Submit comment on Draft 20-Year Transmission Outlook

20-Year transmission outlook

The Bay Area Municipal Transmission group (BAMx)¹ appreciates the opportunity to comment on the Draft CAISO 20-Year Transmission Outlook (20-Year Outlook, hereafter), dated January 31, 2022. The comments and questions below also address the material presented at the CAISO Stakeholder meeting on February 7, 2022. BAMx acknowledges the significant effort of the CAISO staff to develop the 20-Year Outlook.

Figure 1: Transmission Capital Expenditures and HV TAC Projections with CAISO 20-Year Outlook: 2023-2036

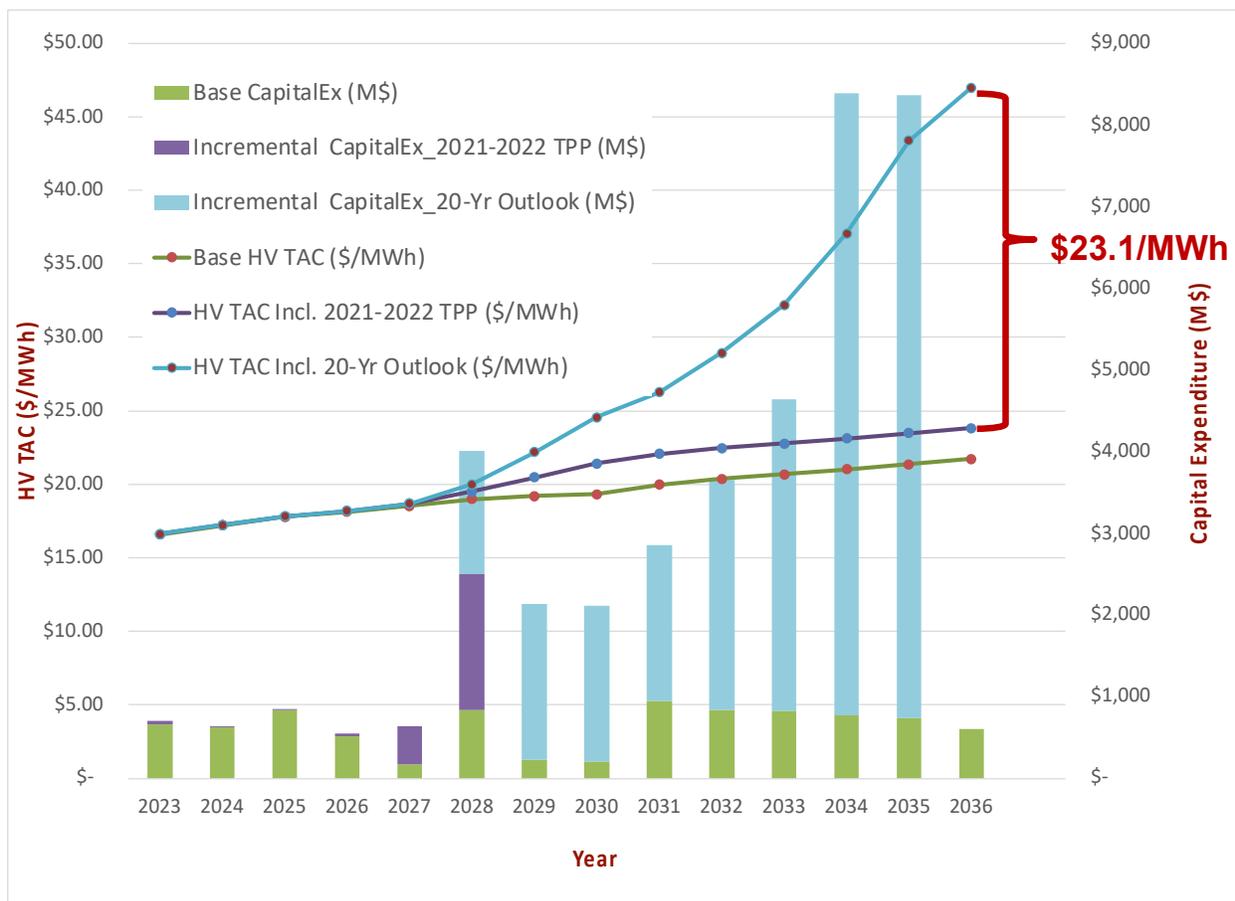
BAMx developed a preliminary HV TAC forecast for 2023-2036, as shown in Figure 1 below. In this analysis, BAMx used the last version of the CAISO’s TAC Estimating model developed for the 2020-2021 TPP, and updated the model to include the CAISO January 01, 2022, TAC Rates (updated as of February 8, 2022). The newly added capital expenditures associated with the transmission projects was based on the transmission projects found to be needed in the 2021-2022 TPP as per the Draft Plan¹¹ and for transmission development to integrate the resources in the SB100 Starting Point scenario as included in the 20-Year Outlook.¹²

As shown in Figure 1 above, the HV TAC is expected to be as high as approximately **\$47/MWh** in 2036 relative to the existing **\$16.60/MWh**, a **190%** increase in the 14-year timeframe.¹³ These HV TAC projections show the extraordinary impact these projects will have on the ever-increasing

¹³ This preliminary HV TAC forecast (first Y-axis) assumes a sample schedule for transmission upgrades (second Y-axis), as shown in Figure 1. It does not consider high electrification load projection by 2040 assumed in the 20-Year Transmission Outlook.

Figure 2: Transmission Capital Expenditures and HV TAC Projections Subjecting All OOS Transmission Projects to Subscriber Model: 2023-2036

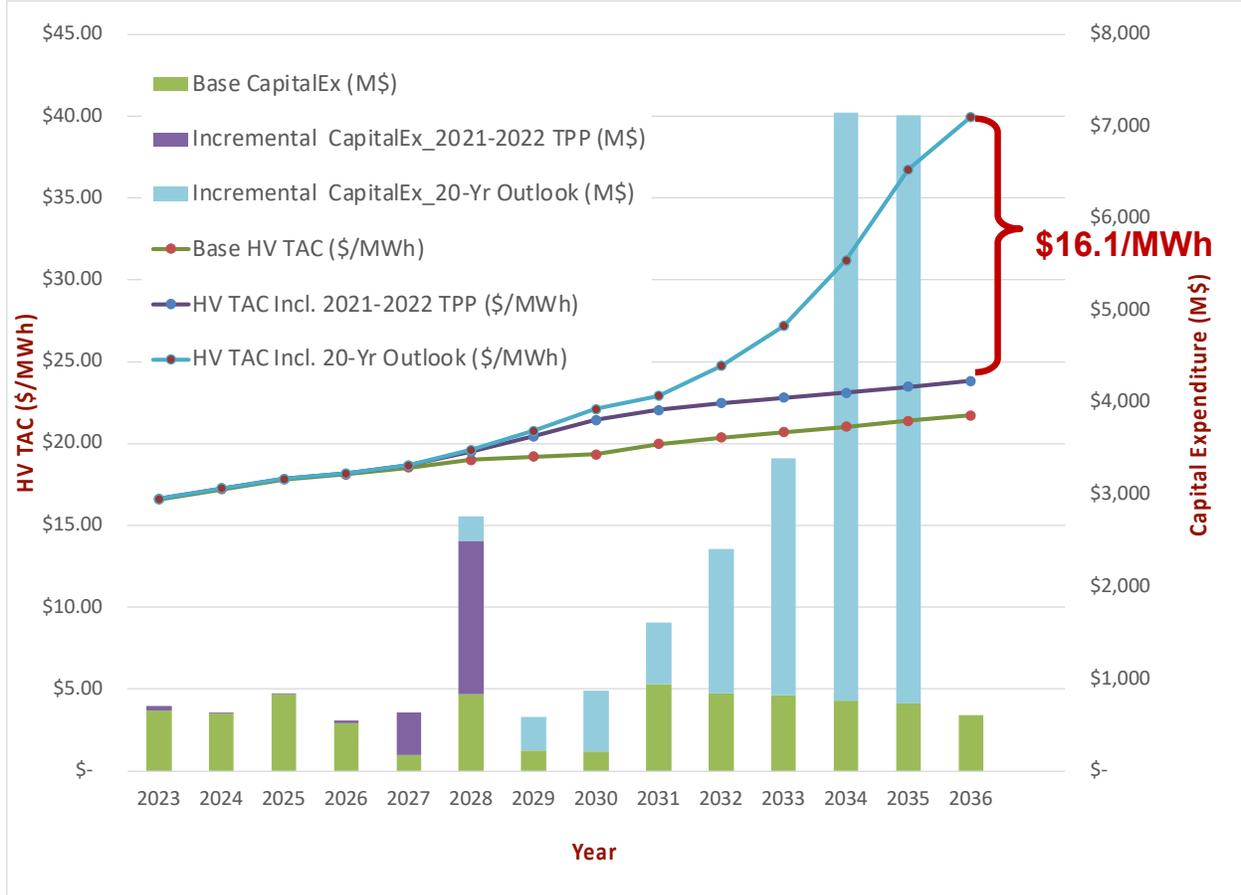
BAMx believes that the subscriber model should be applied to the remaining OOS projects and would have a tremendous positive impact in containing the ever-growing TAC. For example, as shown by Figure 2 below, if all transmission projects to access OOS wind envisioned in the 20-year outlook are subject to the subscriber model, nearly \$9.95 billion of transmission costs will not be recovered via CAISO-wide TAC. As a result, the projected CAISO-wide HV TAC in 2036 would reduce from **\$47/MWh** to **\$40/MWh**.
